VCU Standard Streetscape Encroachment Package - Revised

Application for Urban Design Committee

Submission Date: April 13, 2023

Typical Brick Paver at Sidewalk Paving with Street Tree Planter

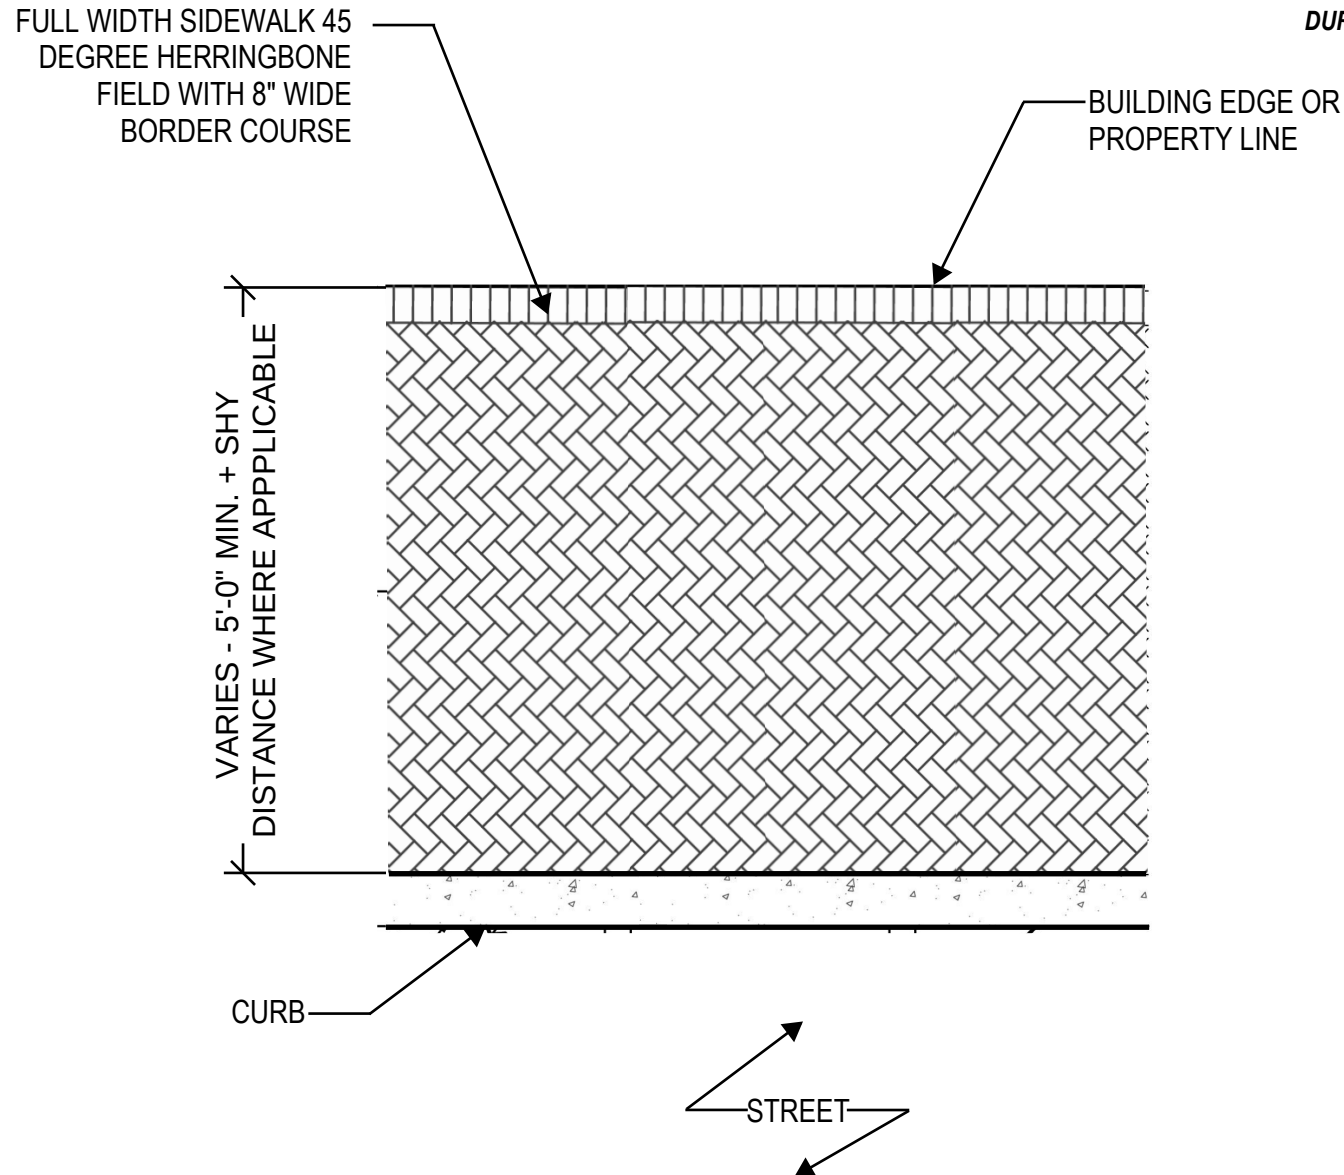
- 2023 Revisions: The revisions being proposed to the 2016 standards pertain to modifying the standard tree well design to better align to the increased tree well size that the City of Richmond has implemented on West Broad Street as well as implementing a raised border curb around the tree well that has been approved on recent projects on VCU's Monroe Park Campus. The increased tree well size improves the health of street trees and deters pedestrians from crossing the street mid block. The raised curb helps keep sidewalk salt out of the tree wells.

WHEN A RAISED CONCRETE BORDER CURB OCCURS ADJACENT TO STREET PARKING, THE PLANTER SHALL MOVED +/- 24" AWAY FROM THE STREET CURB TO PROVIDE CAR DOOR OPERATING CLEARANCE
